Addendum #2

Project: 20250274 - IN083 CAMPUS CENTER - REPLACE BUILDING LIGHTING CONTROLS

Date: February 12, 2026

SHEET NUMBER:
5 of 6

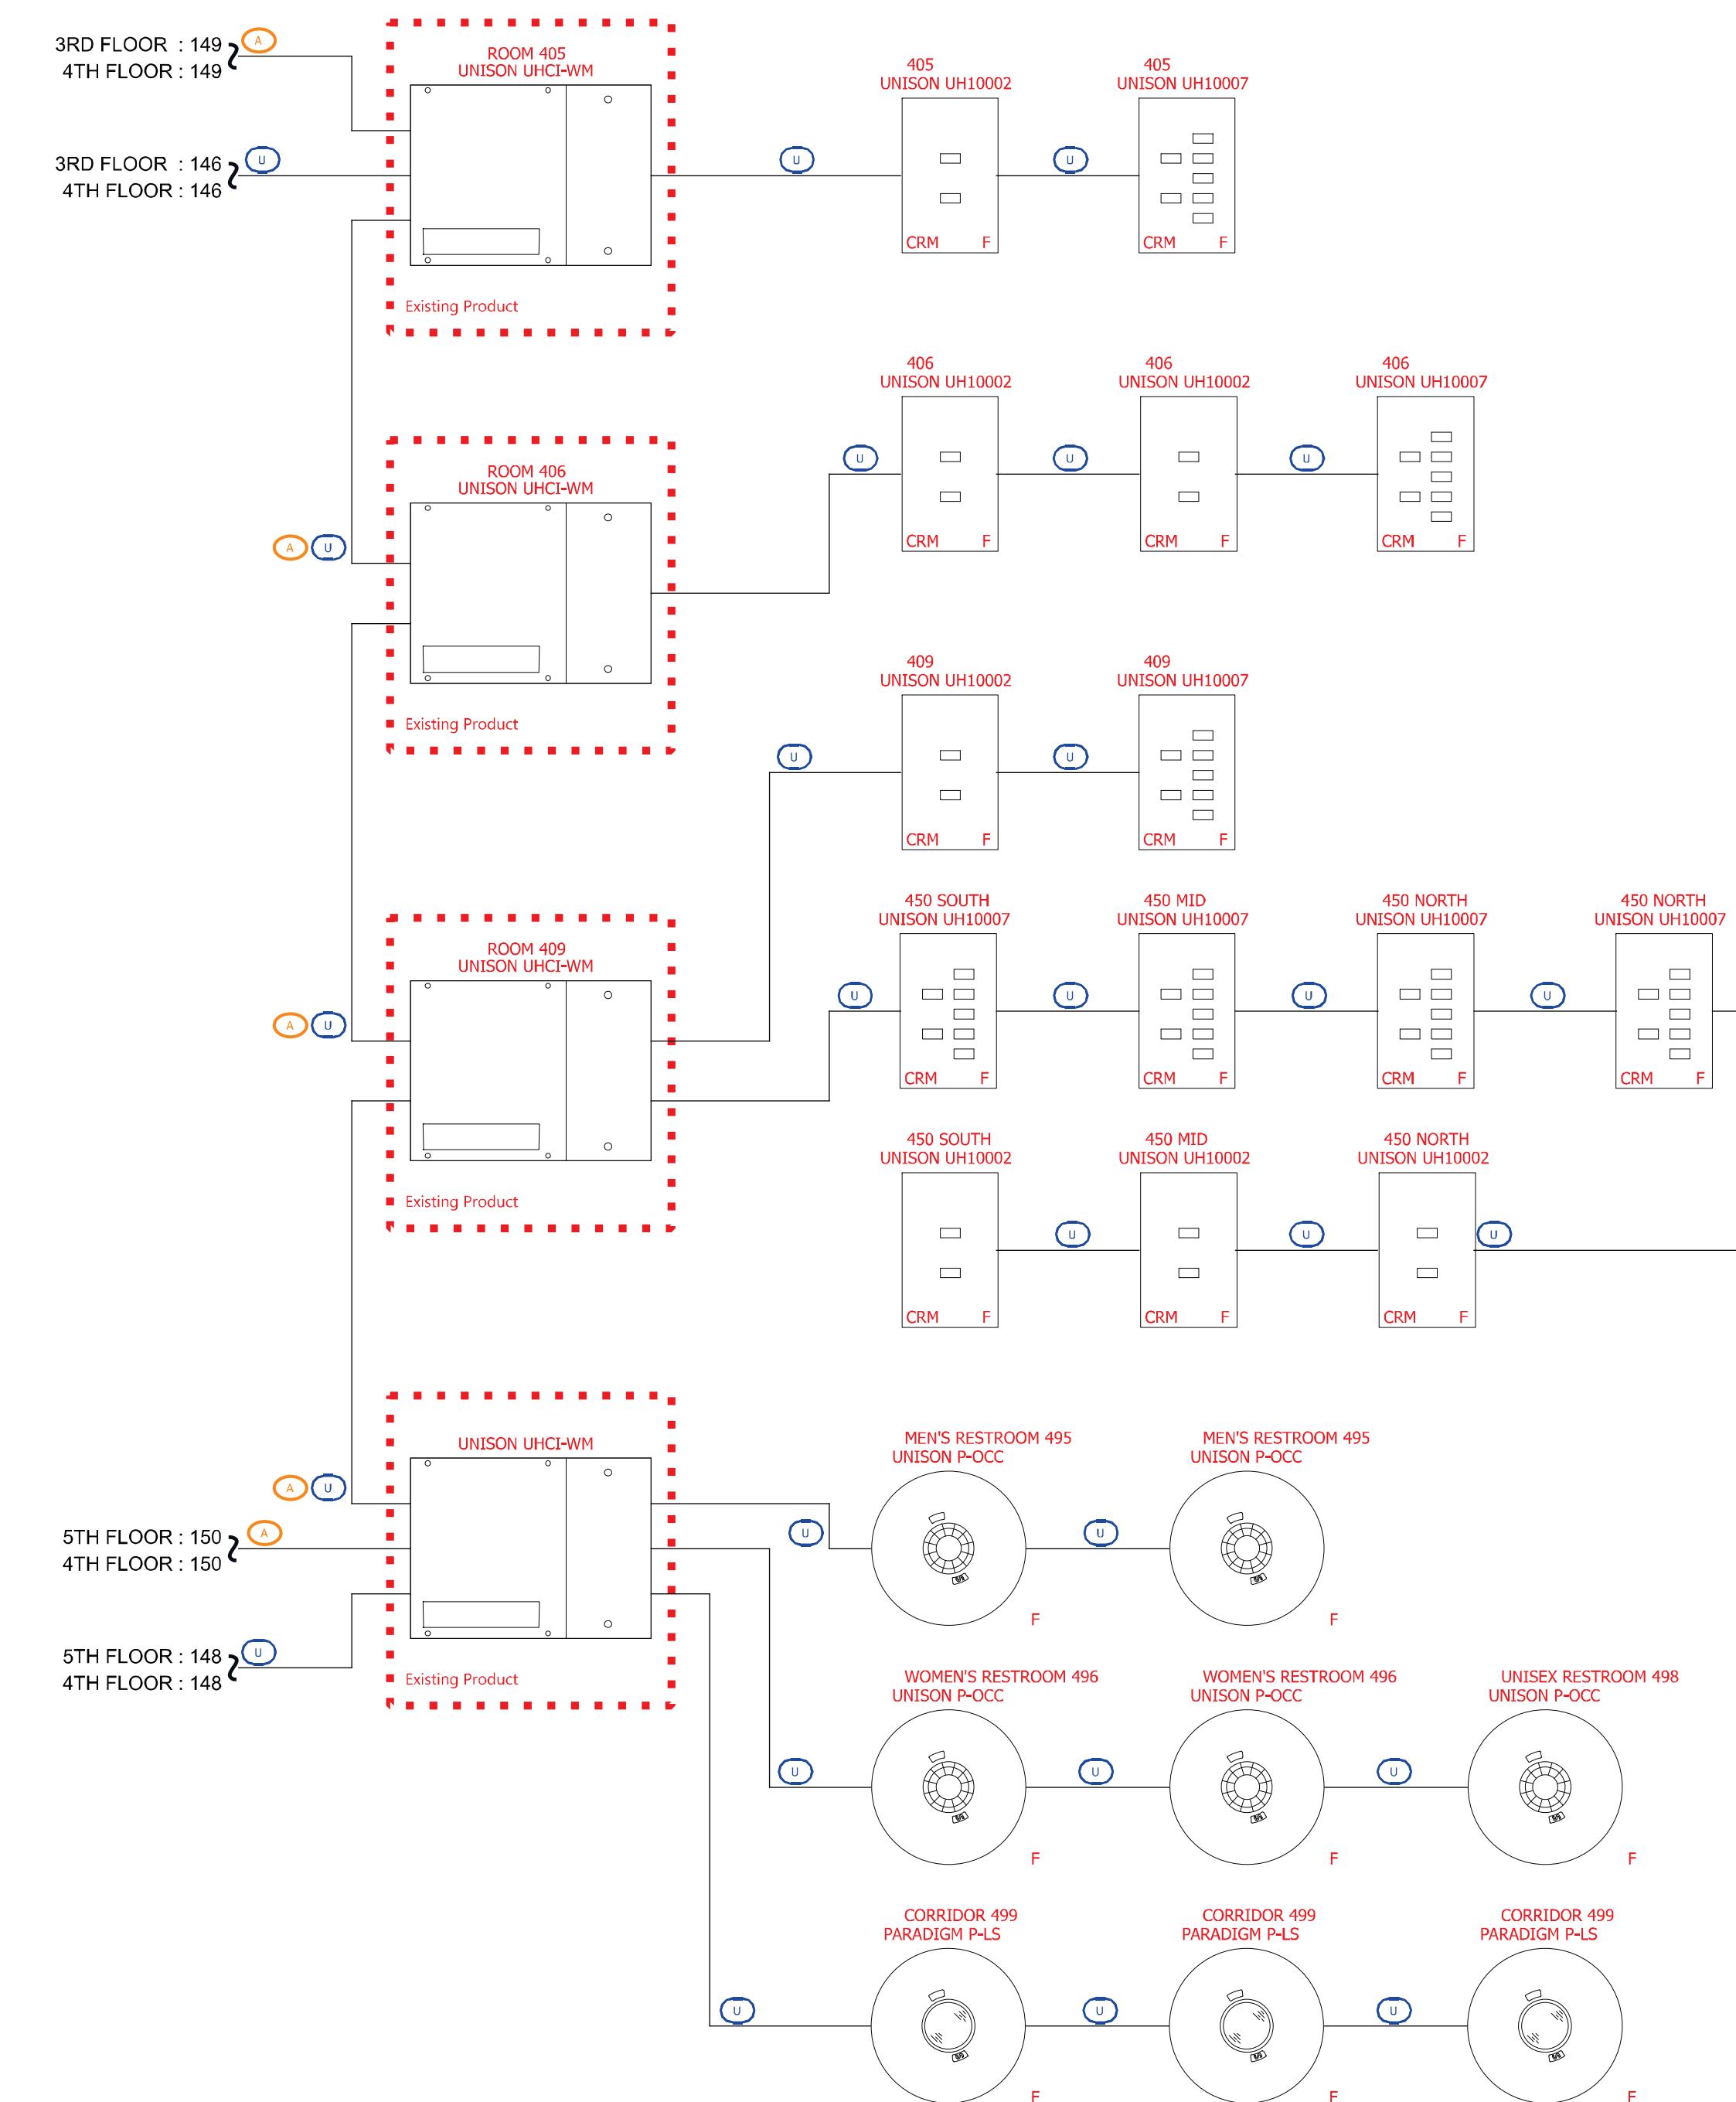
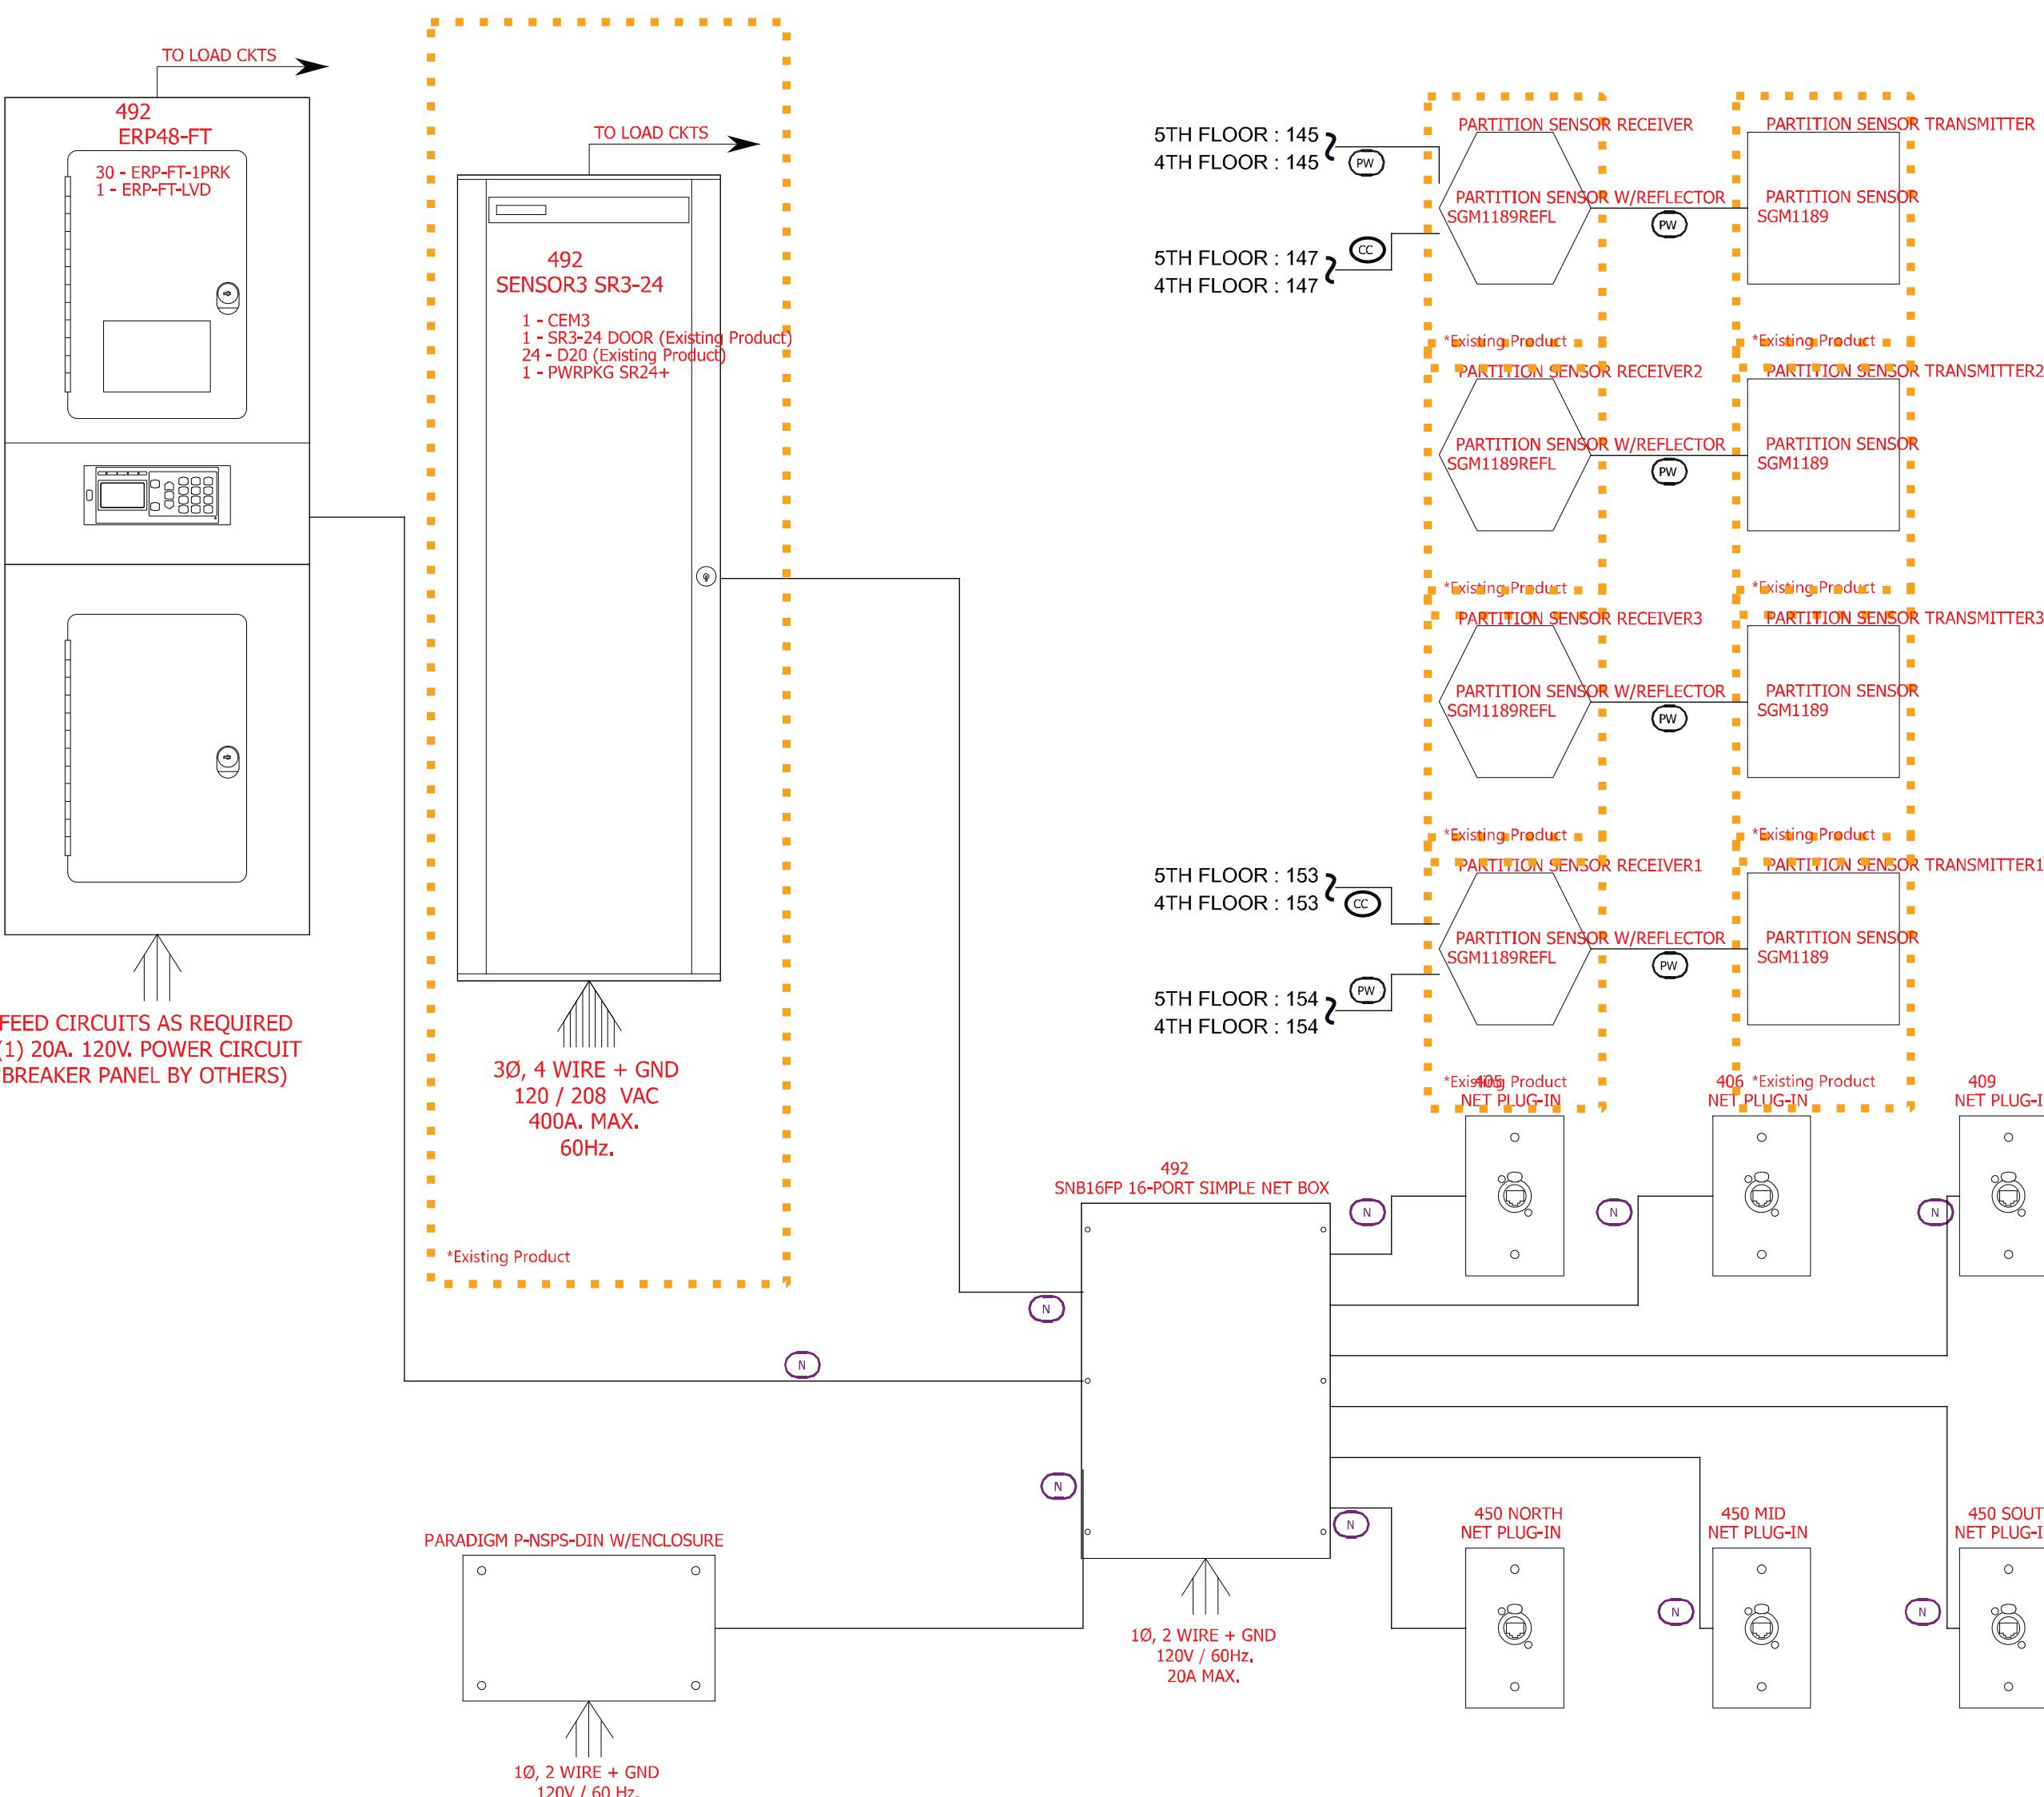
NOTE:
MODULES MAY BE DIFFERENT THAN D20
EXISTING UHCI TO BE J-BOX FOR "U" CABLE
